REVISIONS			
44	05/28/10	ASI #08	
113	10/01/10	ASI #39	
114	10/29/10	CO#83	
128	01/24/11	ASI #51	
209	03/10/11	ASI #74	
308	07/24/11	CO #245	
345	12/19/11	CO#271

PROJECT NAME
CHILDREN'S HOSPITAL OF ORANGE COUNTY
455 S. Main St.
Orange, CA 92668-3874

DRAWING TITLE
LEVEL 3 REFLECTED CEILING PLAN AREA - B

A4.3B

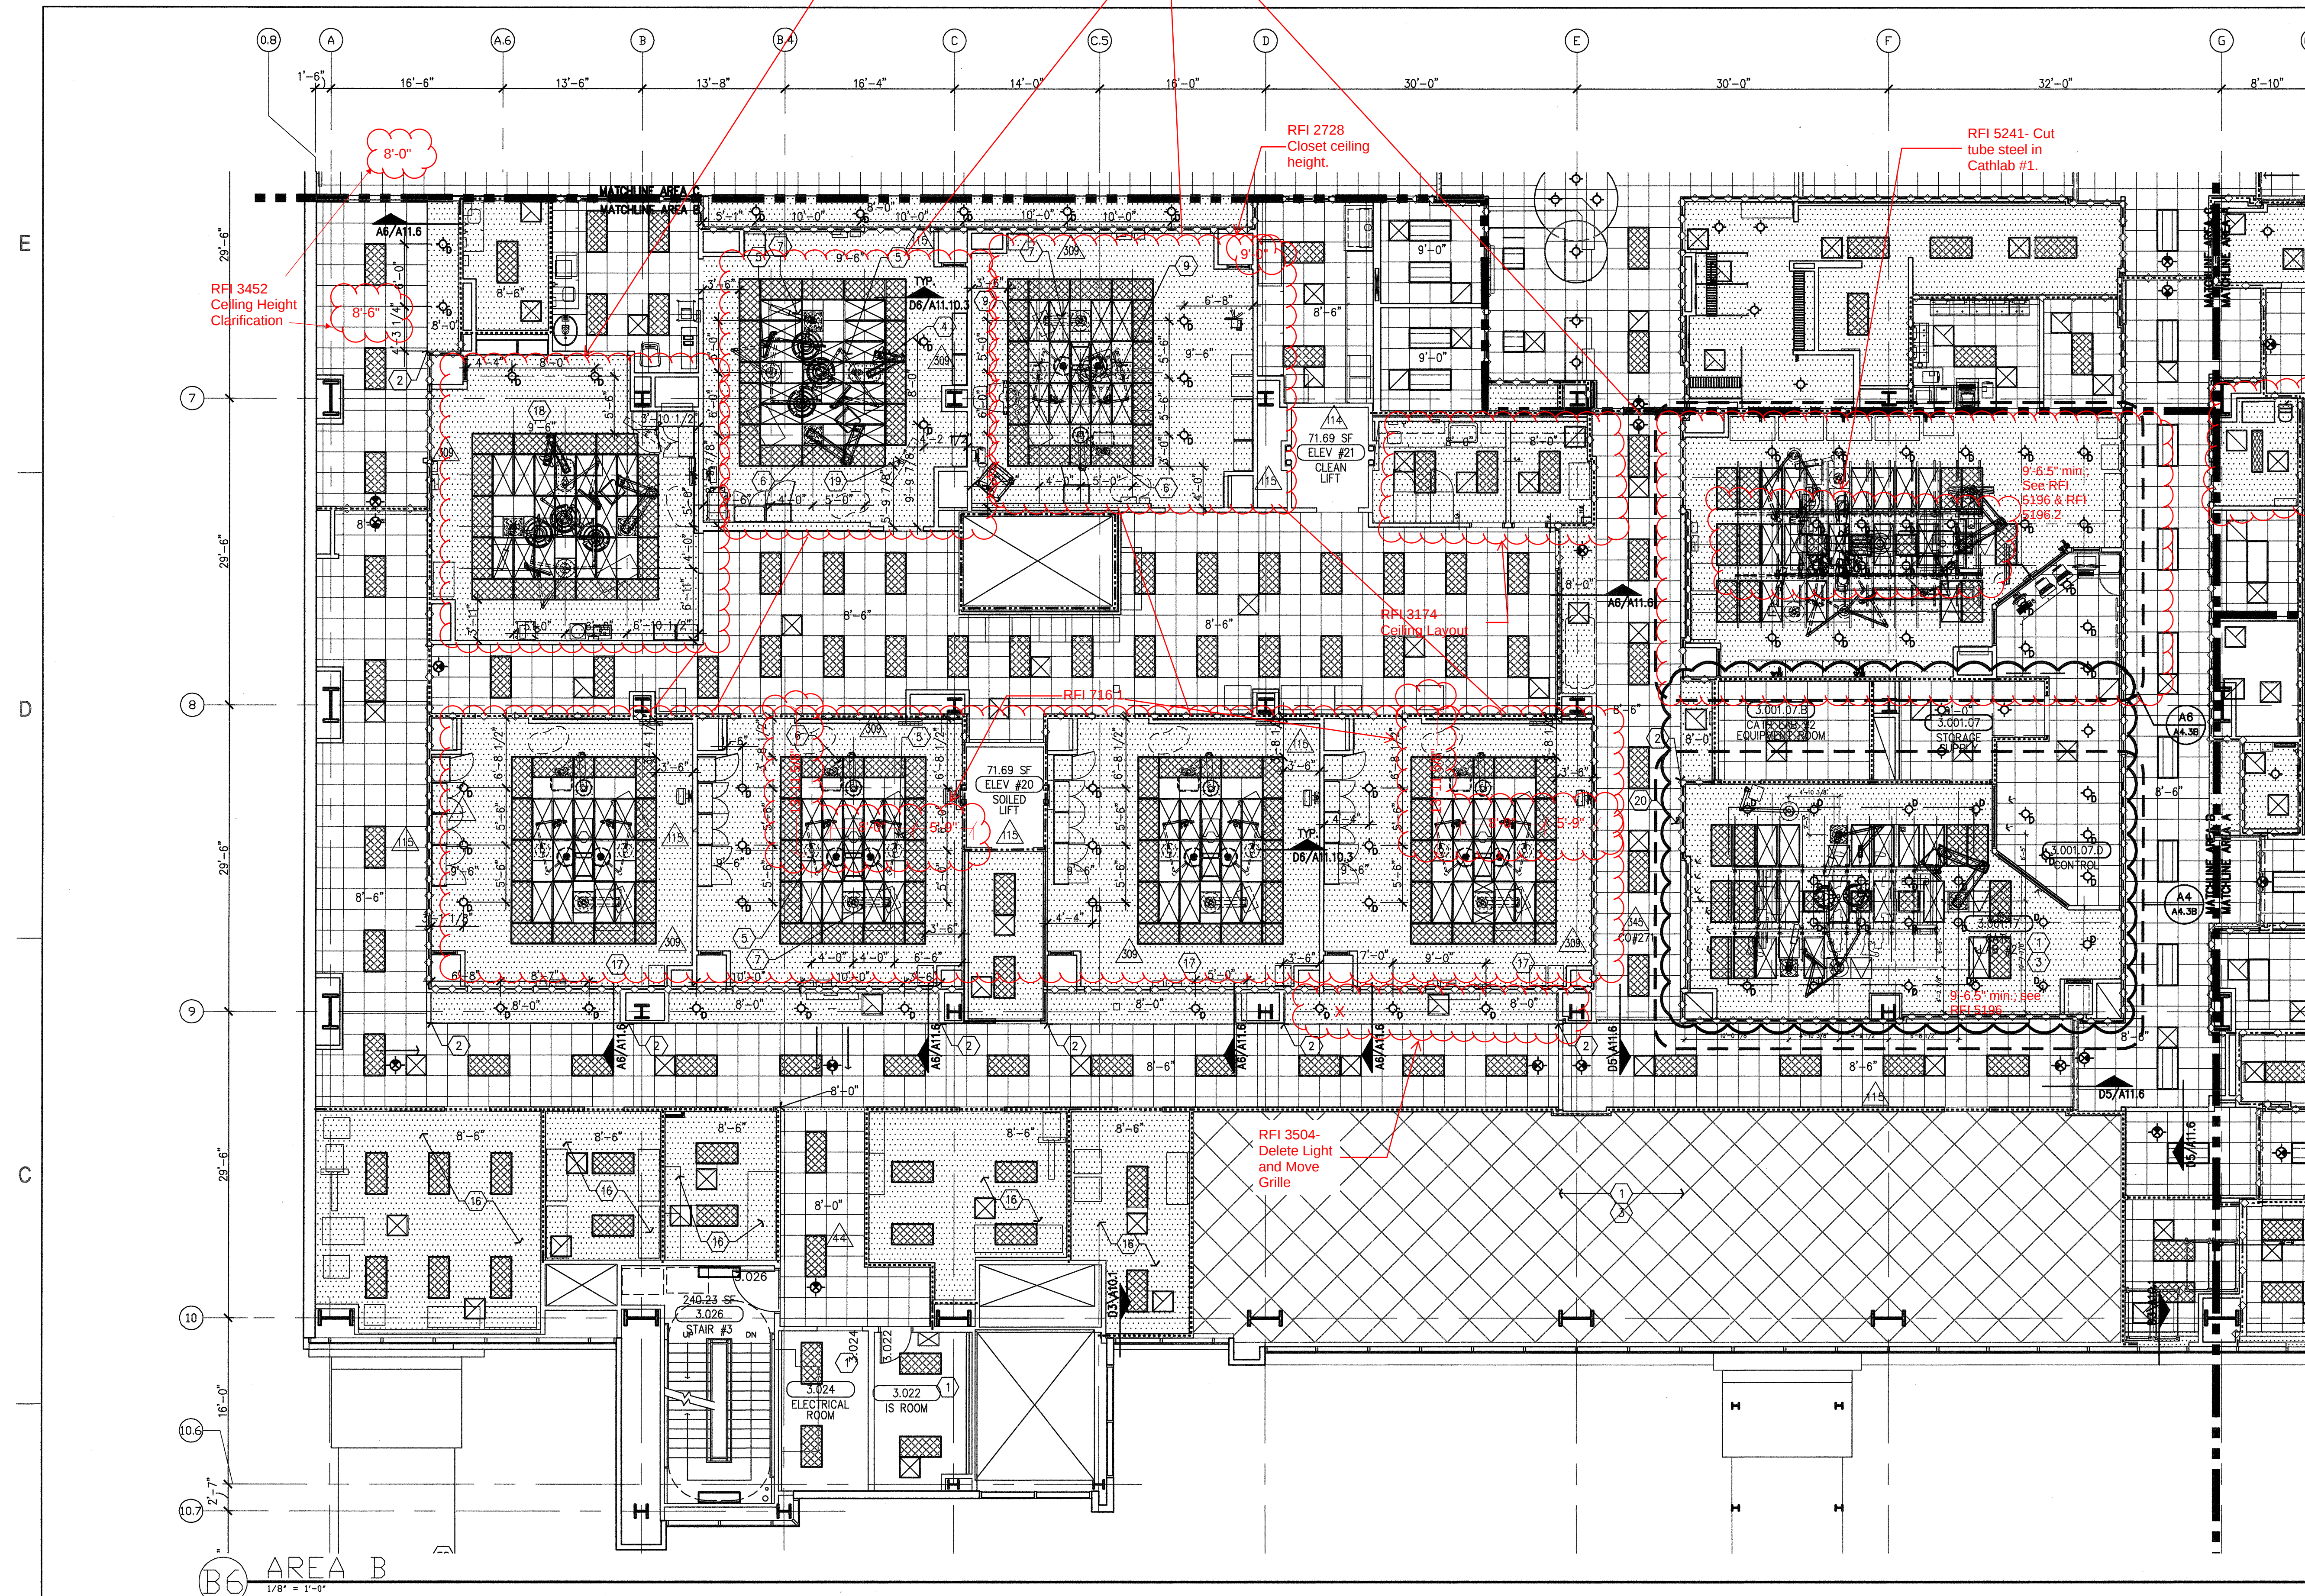
RFI #5494
OR Access Panels
See ceiling layout detail
and materials clarifications
RFI #5048
No ceiling in
cabinet closets
for OR's

RFI #5457
3rd floor RCP
coordination.
